Groundwater and Wastewater Services File Imaging Project
May 2007
Barcode Font = IDAutomationHC39M

Groundwater & Wastewater Services
Septic Project File & Data Review Worksheet

IMPROVEMENT PERMIT for a RESIDENTIAL ON-SITE WASTEWATER TREATMENT & DISPOSAL SYSTEM

RE: Request for an Improvement Permit for Lot 13 off of Sample Road.
MCHD File #6751B

Scale: 1 inch equals 50 feet	S&ME	Faison-Sample Road, LLC	FIGURE
Drawn by: JBP		Lot 13	
Reviewed by: Jeremy P. Michelone, RS		Mecklenburg County, NC	1
Date: March, 2007	ENVIRONMENTAL SERVICES · ENGINEERING · TESTING	S&ME Project #1588-05-091

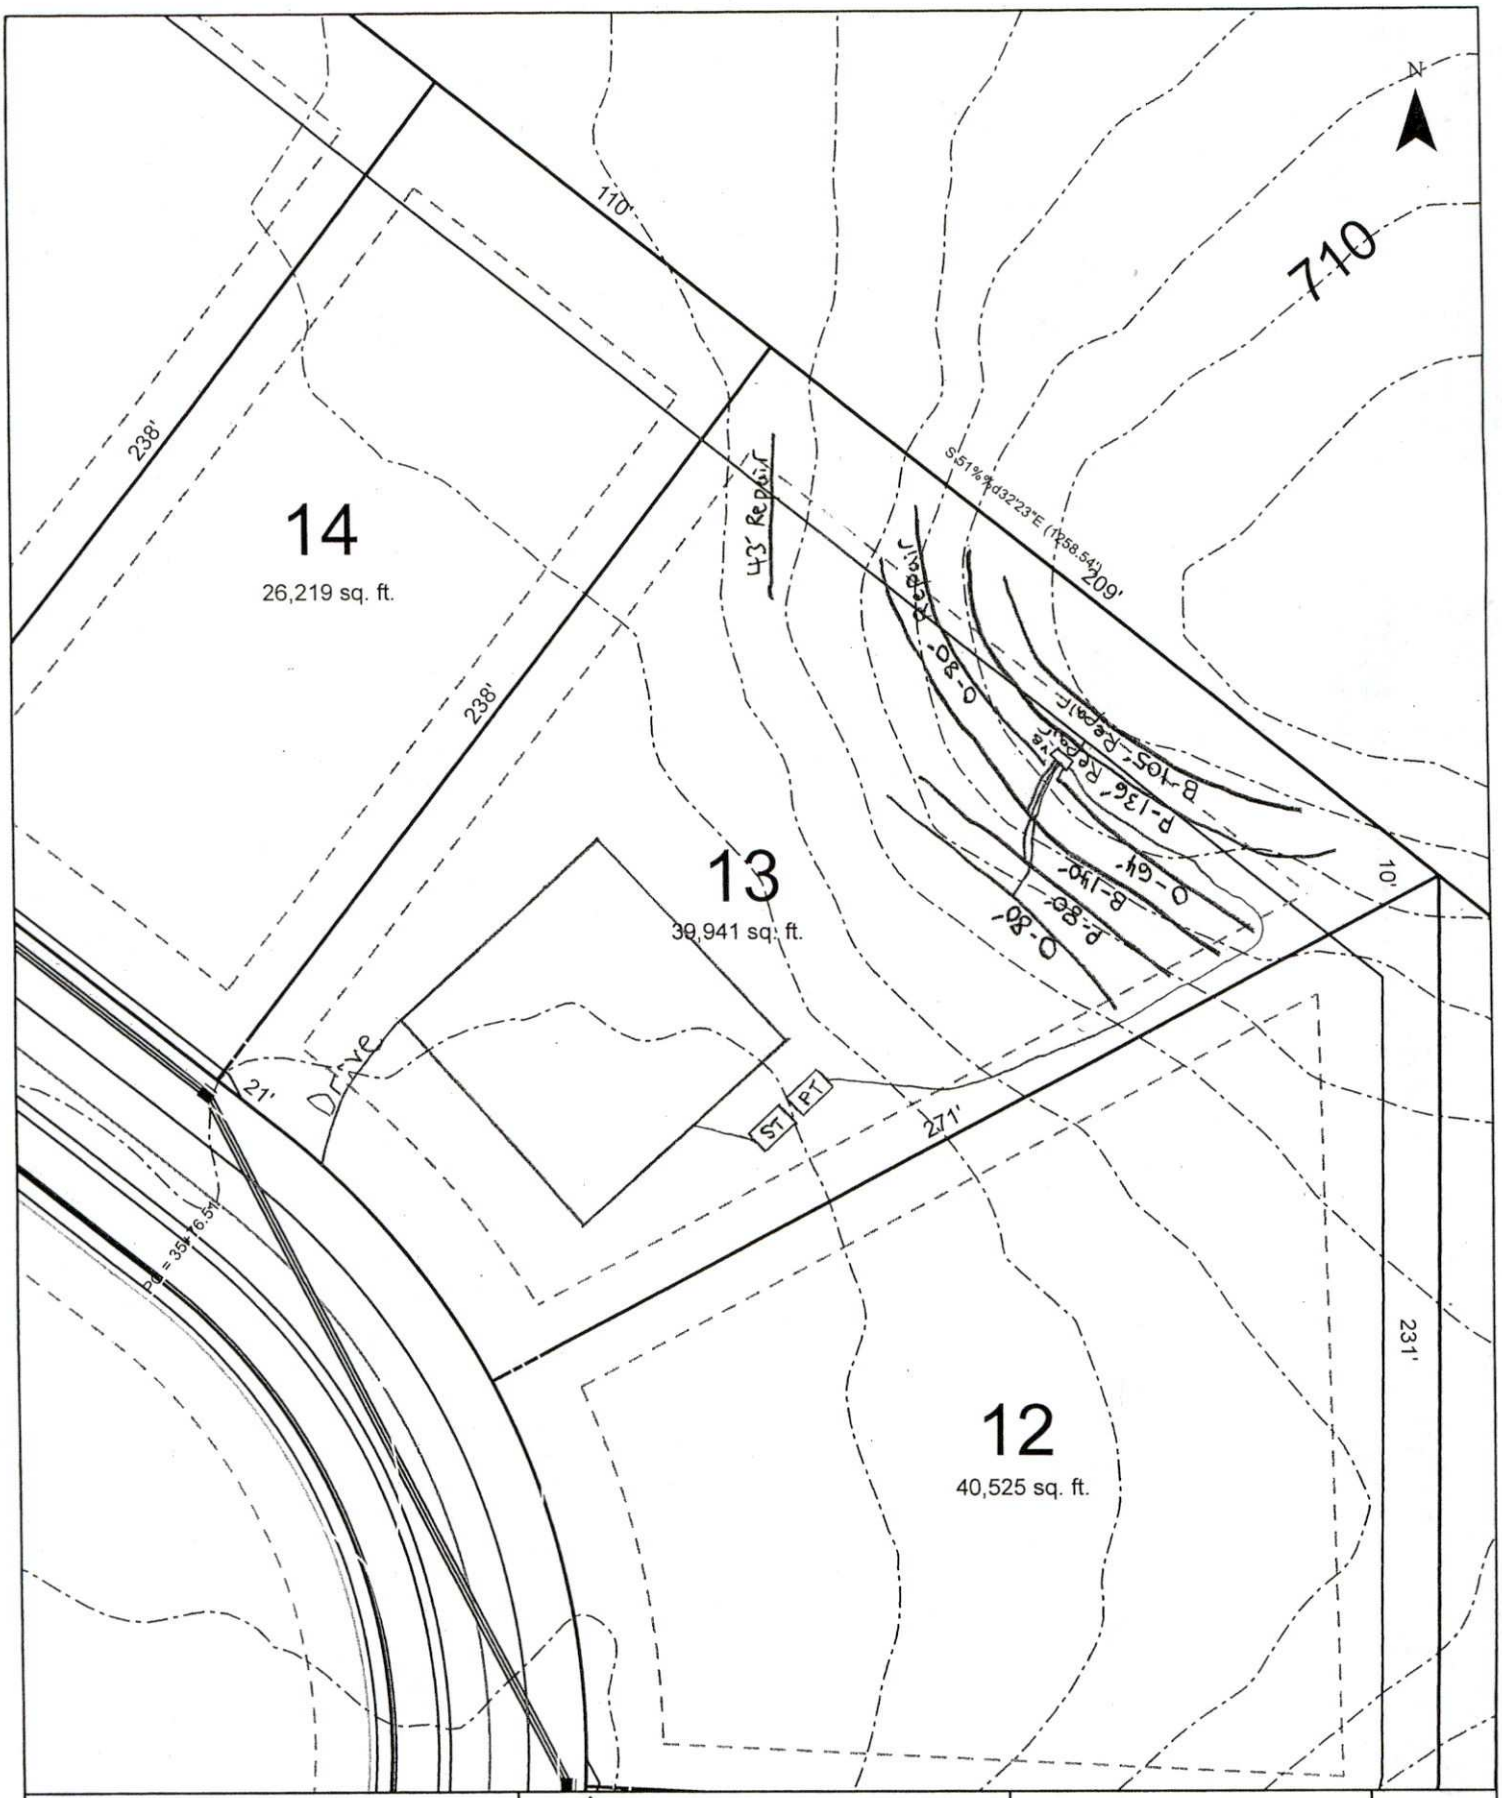
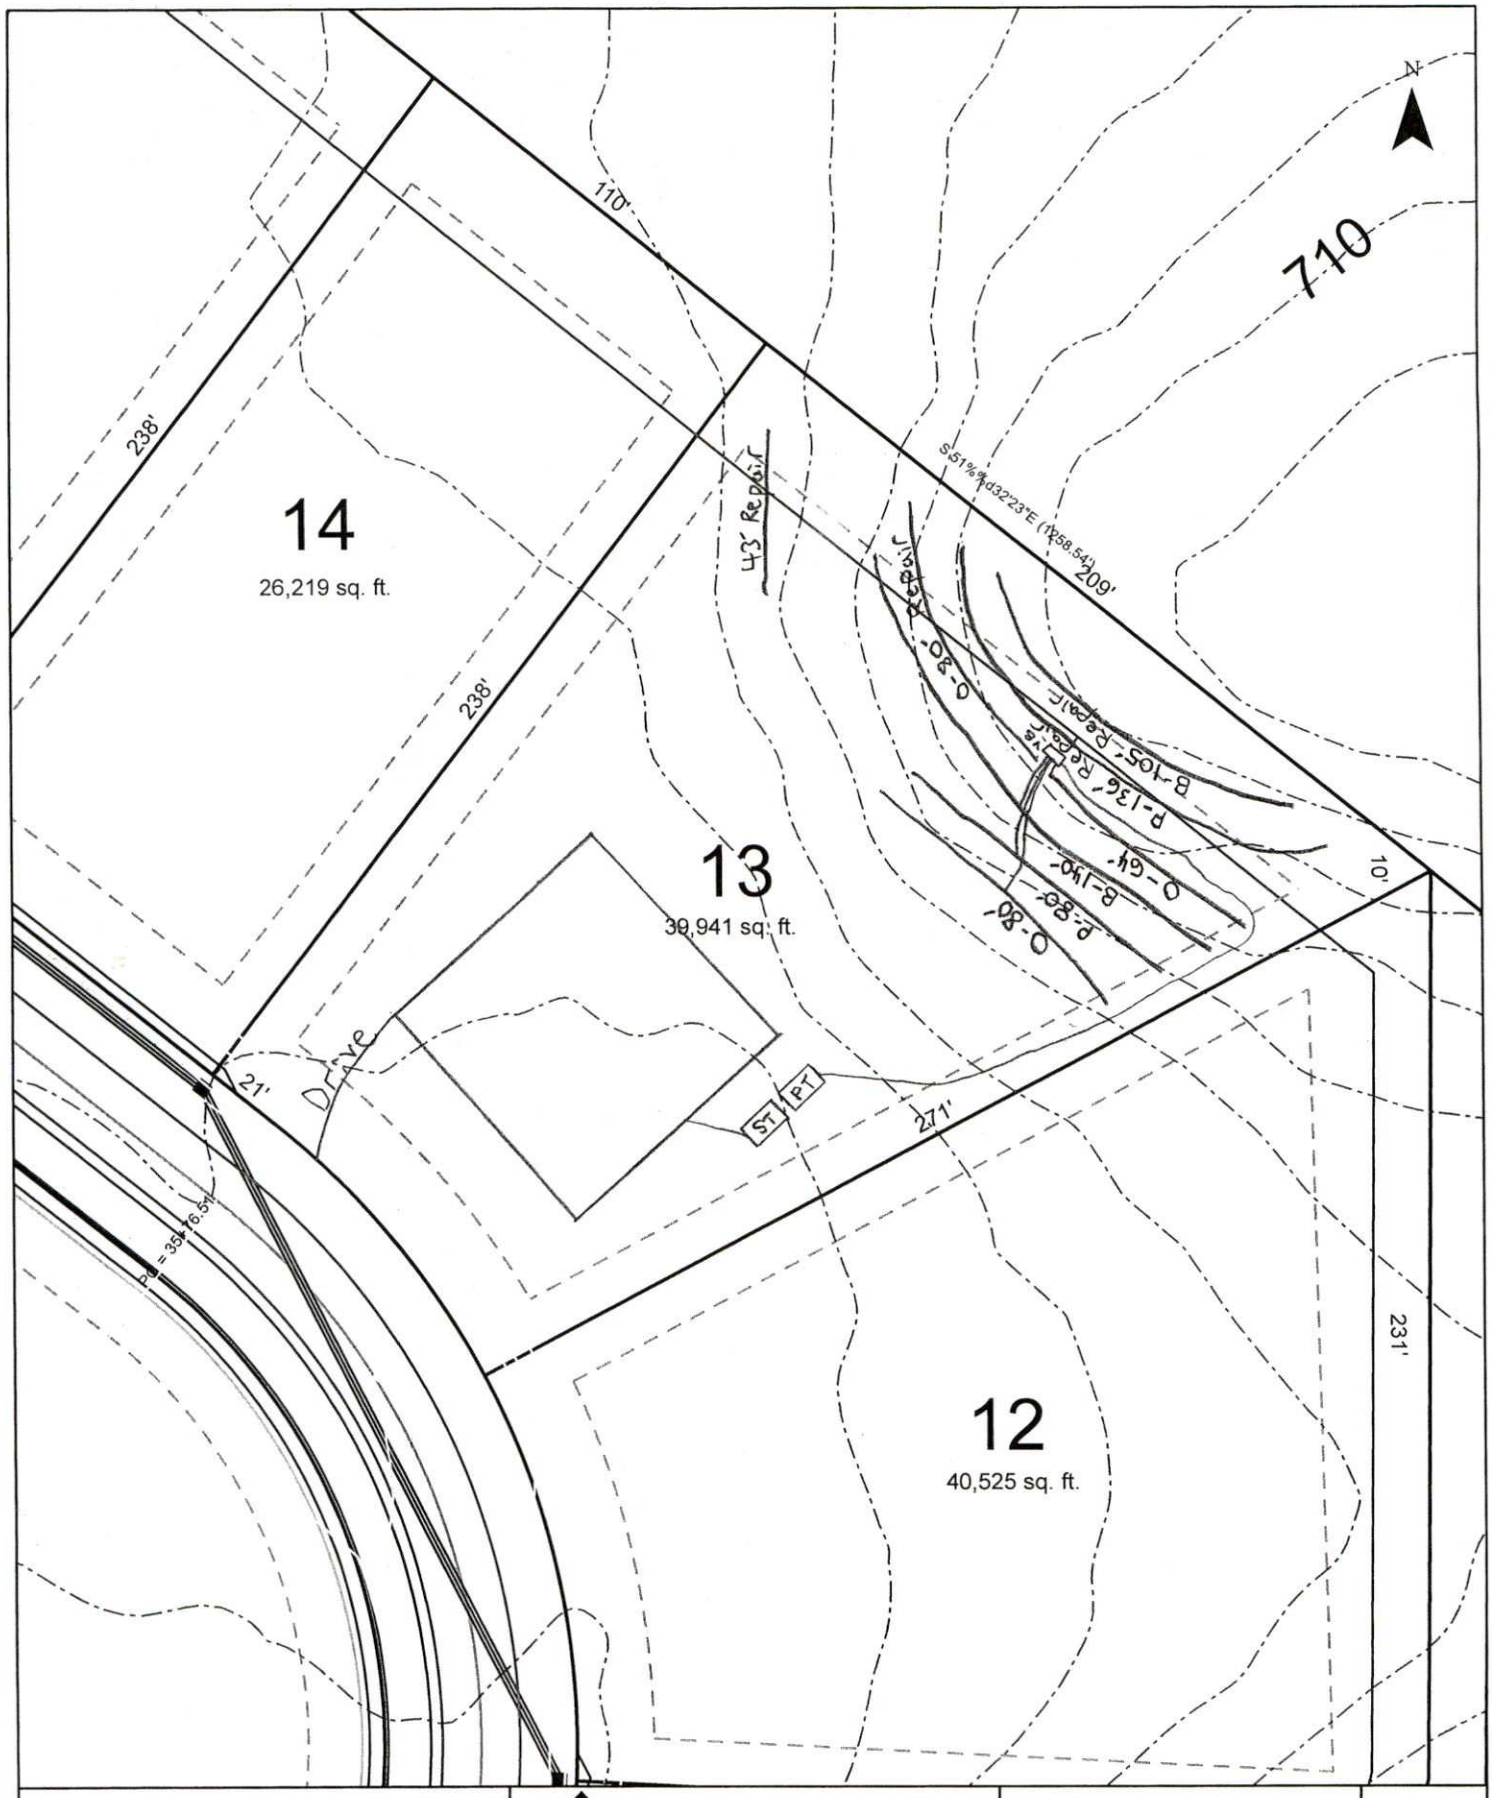
Approved	Disapproved
GWS File #: 6751 B		
Design Review: 03-22-2007	☐	☒
Field Review: JM	☒	☐
